Enclosed are modified responses to the Piping Design Audit open items A-6 and A-26. Also included are the calculational summary for the SRV-quencher and pedestal weld stress analysis corresponding to open item A-4. In addition, a response is provided for SER item 5.18.

GE-NE
ABWR PROGRAM
MECHANICAL SYSTEM DESIGN
FILE MH-A

SUBJECT : SRV-QUENCHER AND PEDESTAL WELD STRESS ANALYSIS
(Response to NRC/BNL audit comment)

Fig. 1 Quencher Model

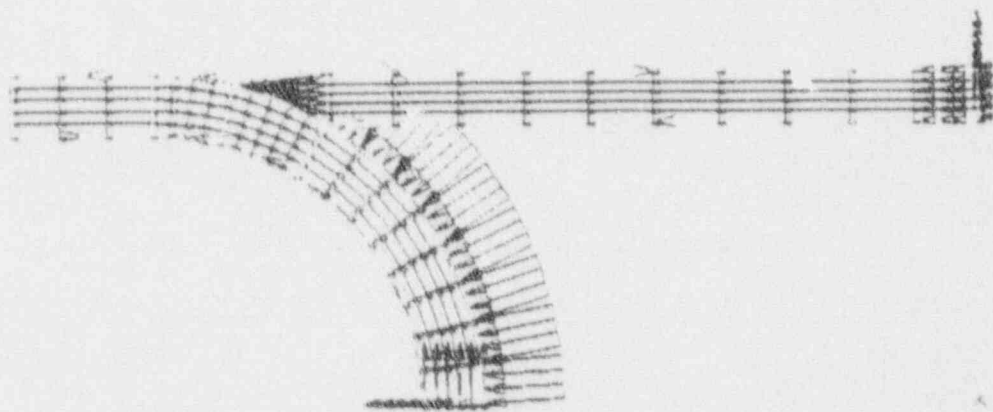
The quencher hub and the pedestal welded region have been analyzed using ANSYS program. The configuration of the analysis model is shown in Figures 1 and 2. The analysis has two purposes. The first purpose is to calculate the effect of the SRV blowdown transient. The second purpose is to calculate the effect of the geometrical discontinuity at the quencher hub and the pedestal weld.

FIGURE 3b HEAT TRANSFER SURFACE

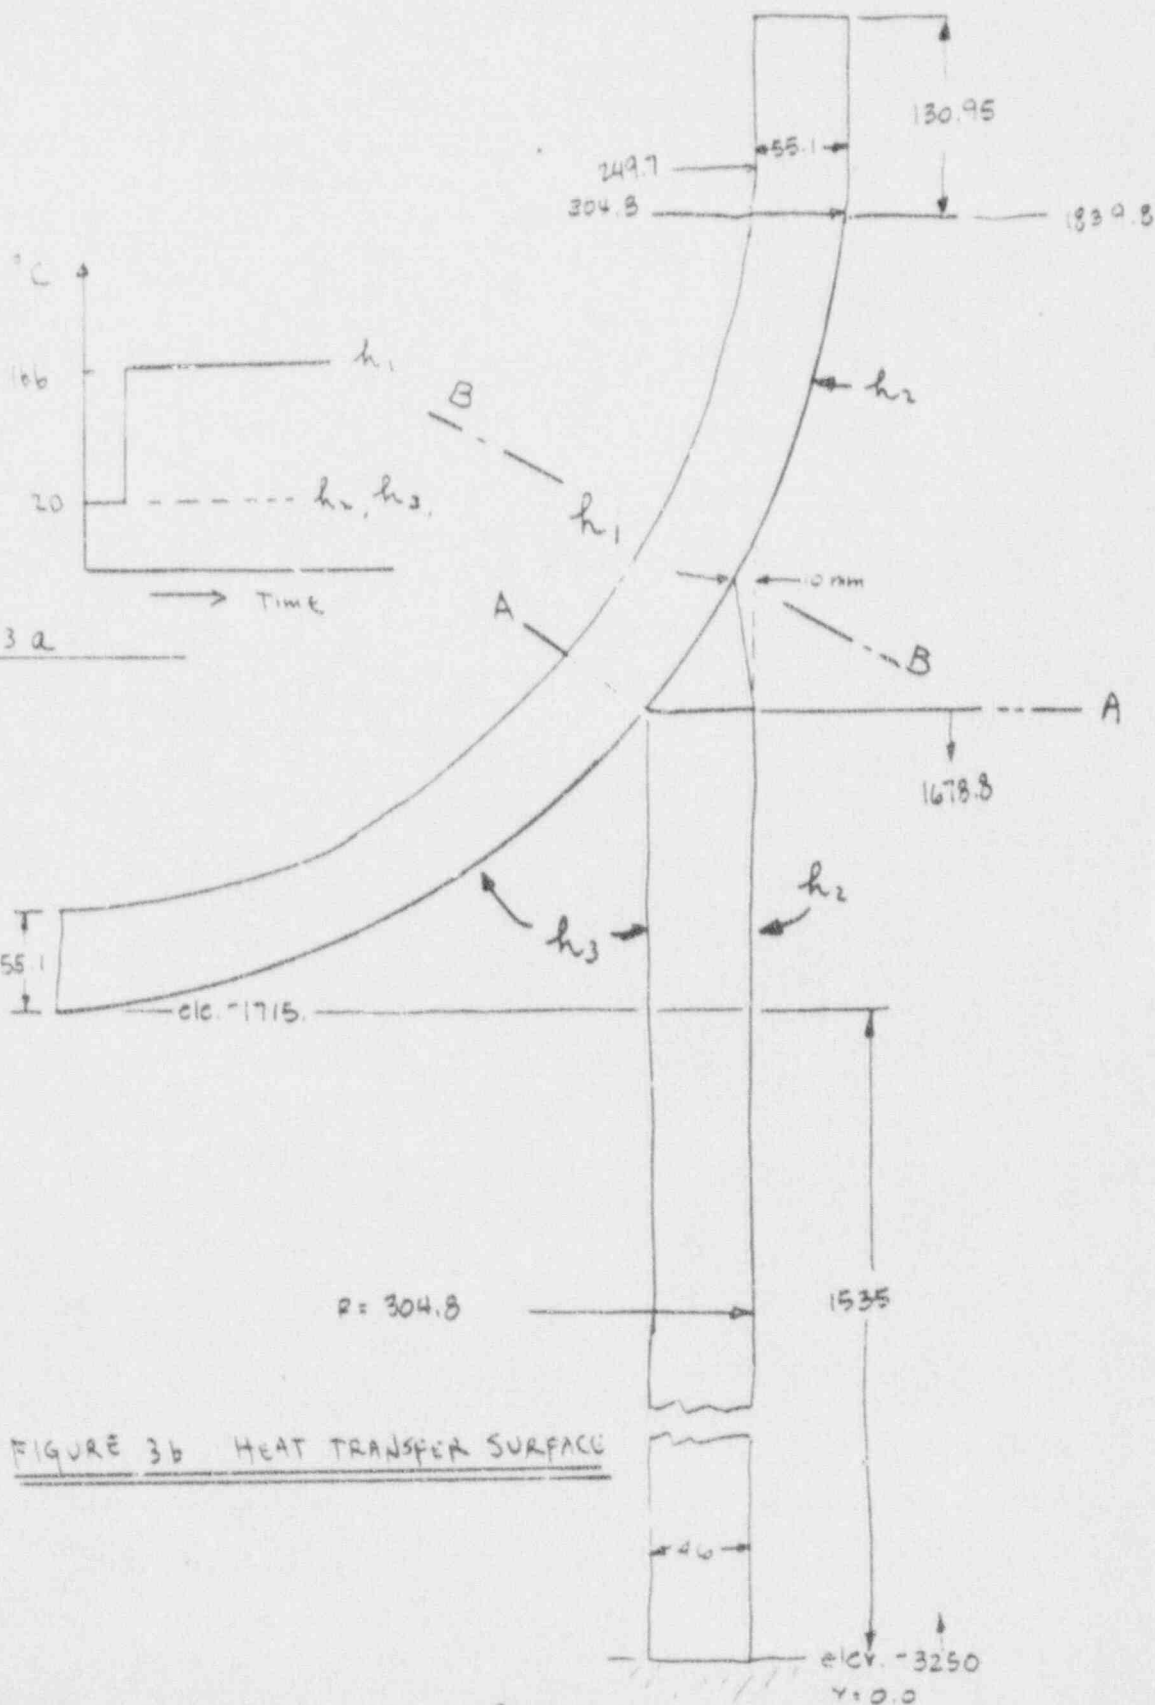
The application of the heat transfer transients to the surface is shown in the figure below:

The boundary condition of the quencher is considered to be the most severe condition in the SRV discharge system. The reason is that the water outside the quencher has cooling effect and the steam inside has heating effect.
